Design Review Report – Item 1

Local government:	City of Stirling	
Item no.:	Item 1 – PDA24/0072 – 73 Wanneroo Road, Tuart Hill - Pre Development Application – Childcare Centre	
Chairperson:	Philip Gresley	
Panel members:	Tony Blackwell Jackson Liew Lisa Shine	
Local government officers:	Dean Williams Karina Bowater Simone Palmer	Coordinator Planning Senior Planning Officer DRP Support Officer
Observers	Meron Nega	Planning Officer
Date:	5 December 2024	Time: 2pm
Venue:	City of Stirling – Challenger Room

Design quality evaluation Item 1 – PDA24/0072– 73 Wanneroo Road, Tuart Hill – Pre Development Application – Child Care Premise DRP Meeting – Thursday 5 December 2024		
	S	<i>Design Principle satisfied</i>
	P	<i>Design Principle pending further attention</i>
	N	<i>Design Principle not satisfied</i>
Principle 1 Context and character		<i>Good design responds to and enhances the distinctive characteristics of a local area, contributing to a sense of place.</i>
	P	1a. The Panel appreciates the consideration of context and the steps taken to integrate the proposal into its surroundings, particularly through the well-placed front setback and its integration into the public realm. These el

Elevations

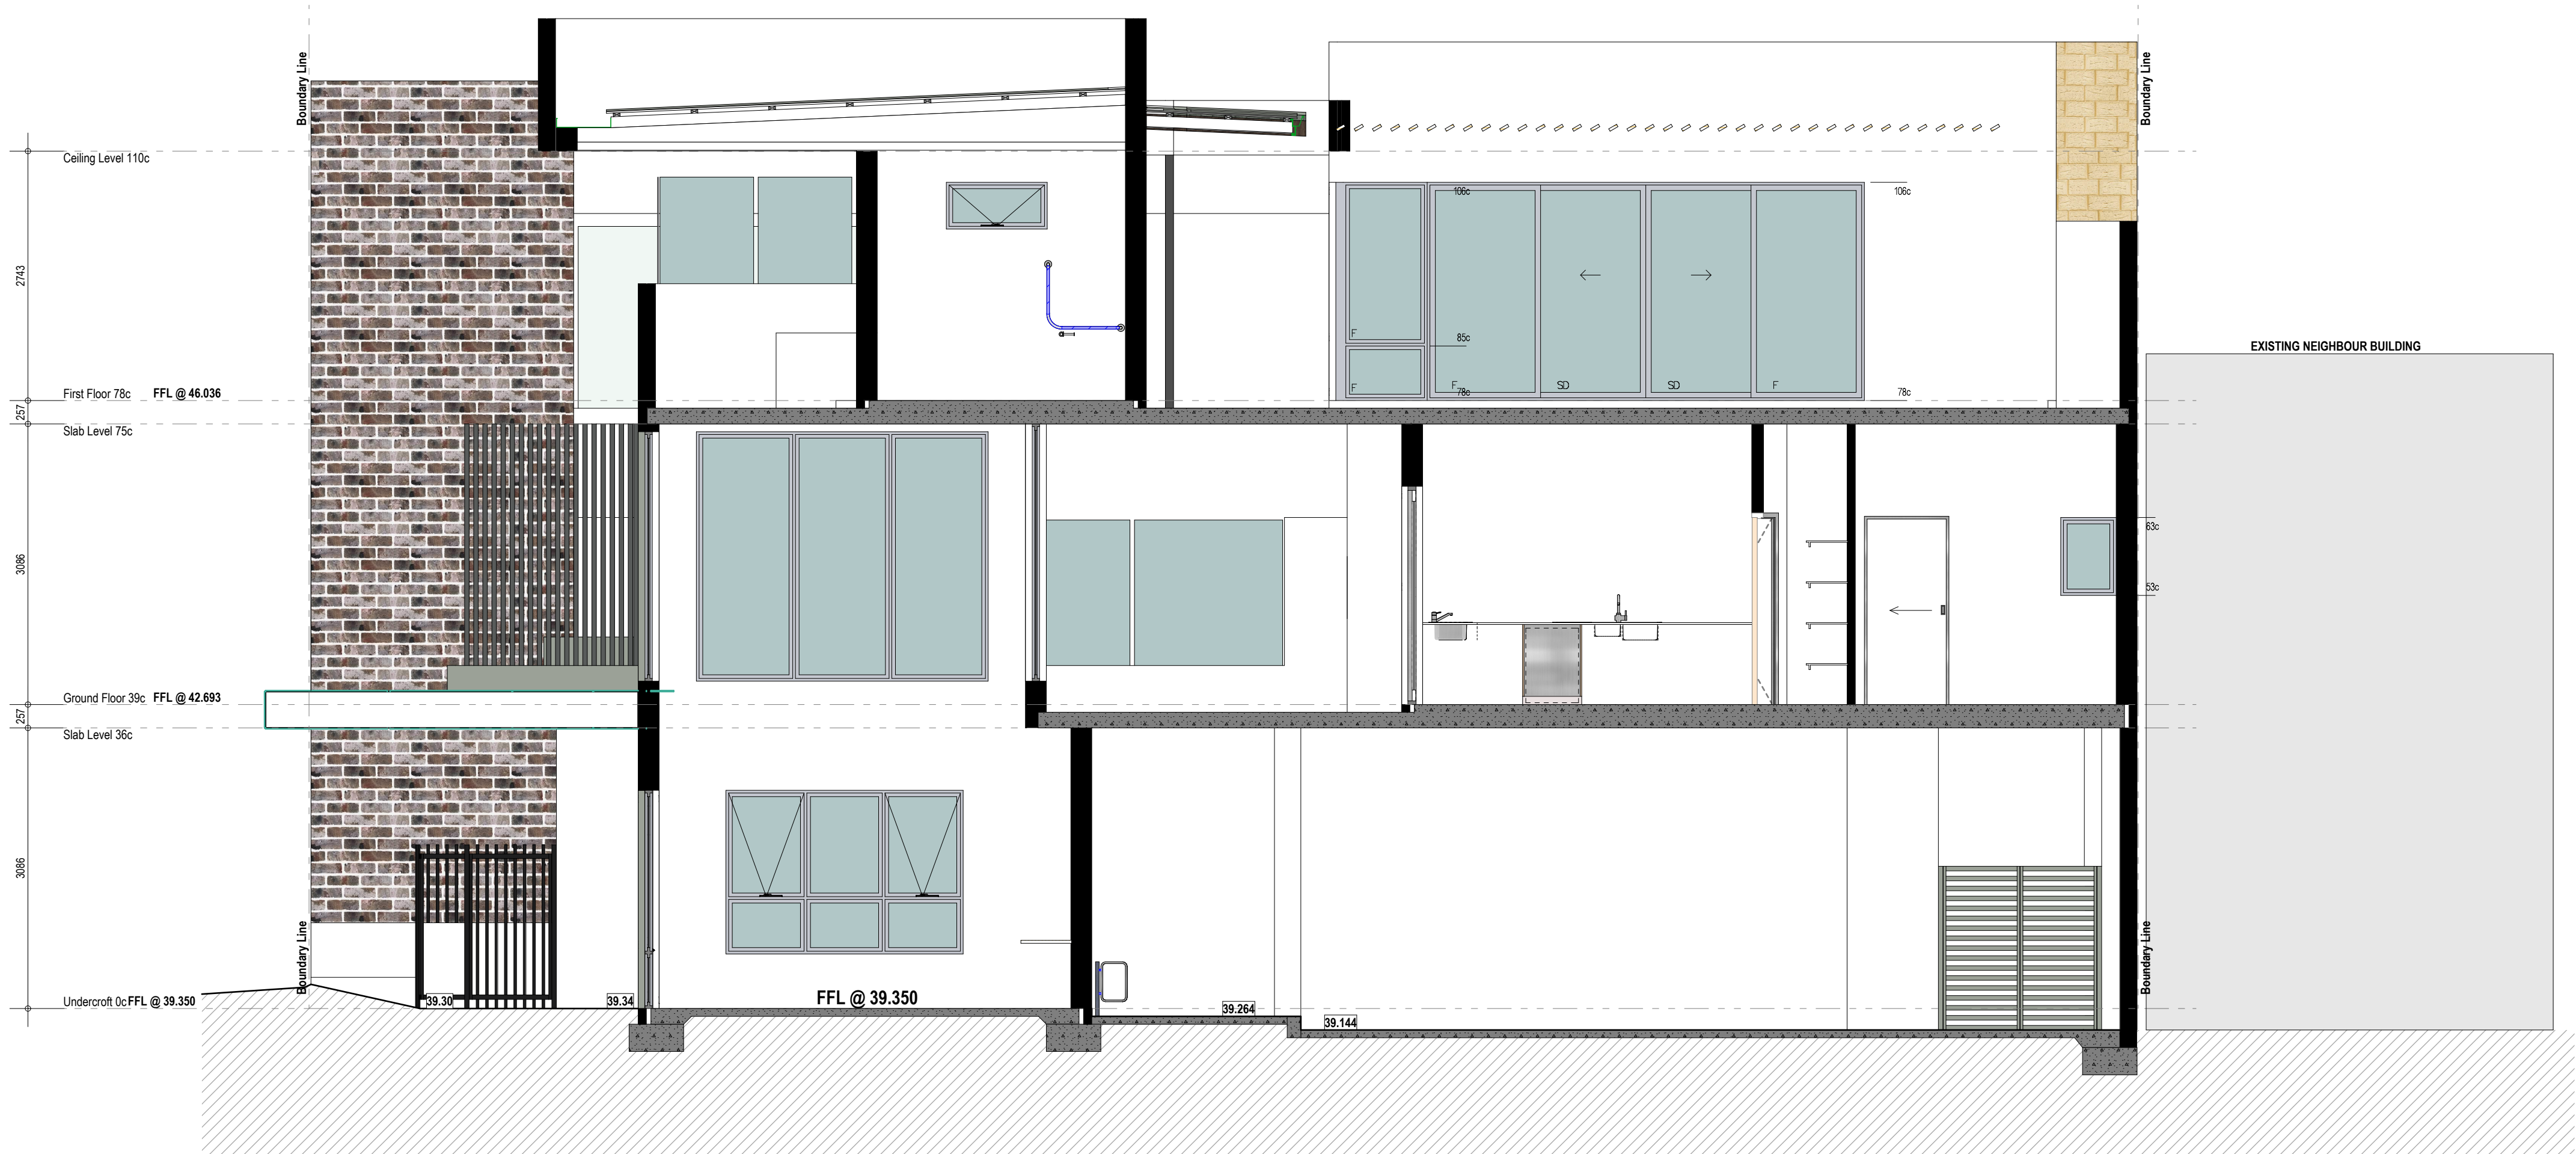
more thought around how the branding will be integrated. 10e. The Panel expressed some concerns around the lack of shading to the east and west elevations for summer heat gain. There is an opportunity to introduce shading elements to further enhance the elevations, especially on the Wanneroo Road elevation. 10f. The proposed green feature element at the corner is considered superfluous and does not adequately contribute to site identity. A more architectural corner treatment should be explored to strengthen the site's presence and interface with the public realm. 10g. There is opportunity to carefully integrate playful design elements in the southern elevation to create a more welcoming environment for children.	
--	--	---	--

PLANTING PALETTE

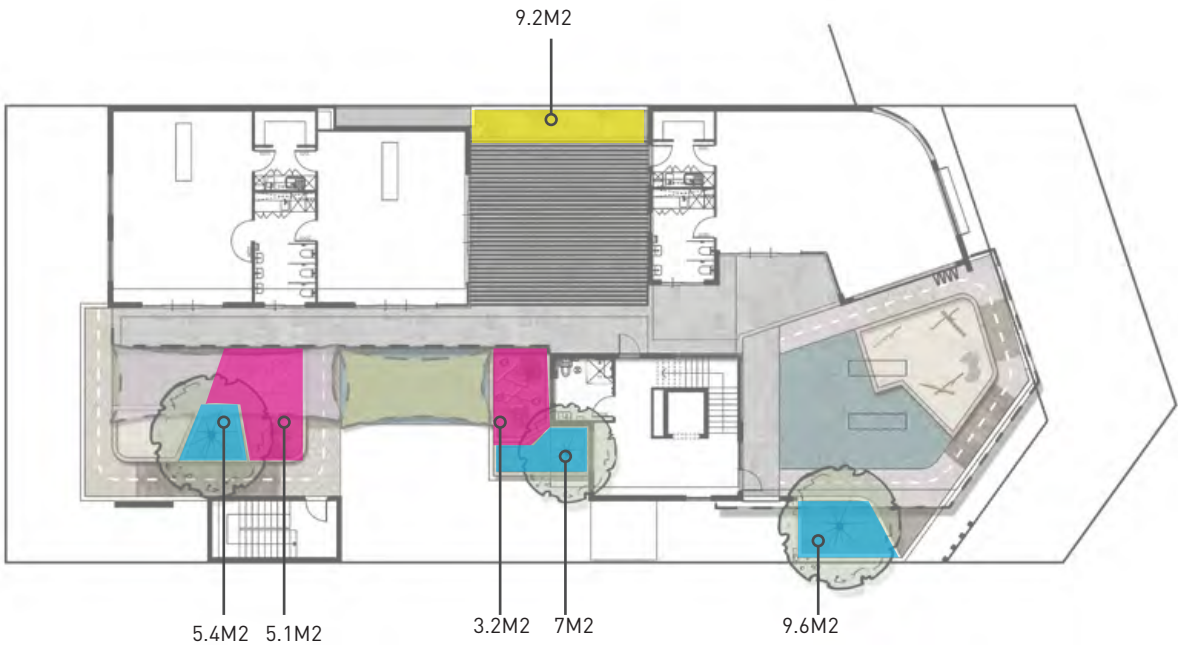
2g. The Panel suggested that some of the brickwork elements from the façade could be introduced into the landscape to provide material continuity and reinforce the architectural character. 2h. The species list should be reviewed as Magnolia Grandiflora and Cercis Canadensis are on the shot-hole borer list. Replacing them with alternative species that are more resilient is recommended. 2i. Artificial turf is considered acceptable in this scheme due to its shaded location, which significantly reduces toxic gases and minimizes heat gain. However, an overshadowing diagram should be provided to demonstrate this and ongoing management and maintenance of this surface should be considered. 2j. The ground level tree to the west of the entry way may be somewhat constrained. This would benefit from additional consideration and could be better integrated to enhance the entry way and streetscape.
Principle 3 Built form and scale		<i>Good design ensures that the massing and height of development is appropriate to its setting and successfully negotiates between existing built form and the intended future character of the local area.</i>
